Access Compliance Report

Public Rights-of-Way

(Curb Ramps)

Intersection ID: 6957	Main Street: N_TRYON_ST	Cross Street: N_US_29_BY-PASS_HY	Location: SE
ADA ID: 1FFFBC6674A2	Ramp Type: Perp	Initial Pass/Fail: Fail	Overall Compliance: No
Severity Score: 13.75			
Codes/Mitigation Info/Possible Solution		Field Measurements/Component Compliance

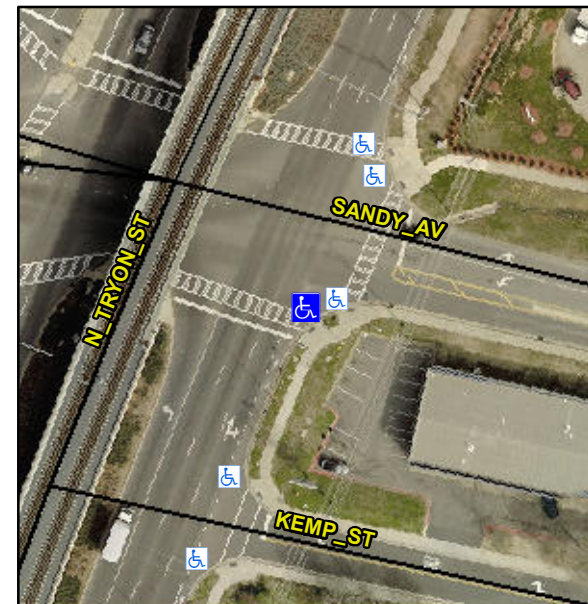
Not Found, R304.2.2, R304.5.3

Compliance	Description	Data	Compliance	Description	Data
N/A	Ramp Length (in)	71.0	No	Ramp Slope (%)	8.9
Yes	Ramp Width (in)	48.0	No	Ramp XSlope (%)	3.1
N/A	Flare Type LT	N/A	N/A	Flare Type RT	N/A
N/A	Flare Slope LT (%)	N/A	N/A	Flare Slope RT (%)	N/A
N/A	Flare Traversable LT?	N/A	N/A	Flare Traversable RT?	N/A
N/A	Landing Length (in)	N/A	N/A	DWS Provided?	N/A
N/A	Landing Width (in)	N/A	N/A	DWS Contrast?	N/A
N/A	Landing Slope (%)	N/A	N/A	DWS Length (in)	N/A
N/A	Landing X Slope (%)	N/A	N/A	DWS Full Width?	N/A
N/A	Landing Curb? (Y/N)	N/A	N/A	DWS Offset (in)	N/A
N/A	Shared Landing?	N/A			
N/A	Gutter Ponding?	N/A	N/A	Gutter Slope (%)	N/A
N/A	Gutter Lip Ht (in)	1.0	N/A	Gutter X Slope (%)	N/A
N/A	Painted X Walk1?	Yes	N/A	Painted X Walk2?	N/A
	X Walk 1 Direction	To NW		X Walk 2 Direction	N/A
N/A	X Walk 1 Width (in)	109.0	N/A	X Walk 2 Width (in)	N/A
	X Walk 1 Slope (%)	5.0		X Walk 2 Slope (%)	N/A
	X Walk 1 X Slope (%)	1.3		X Walk 2 X Slope (%)	N/A

Remove & Replace Entire Ramp.
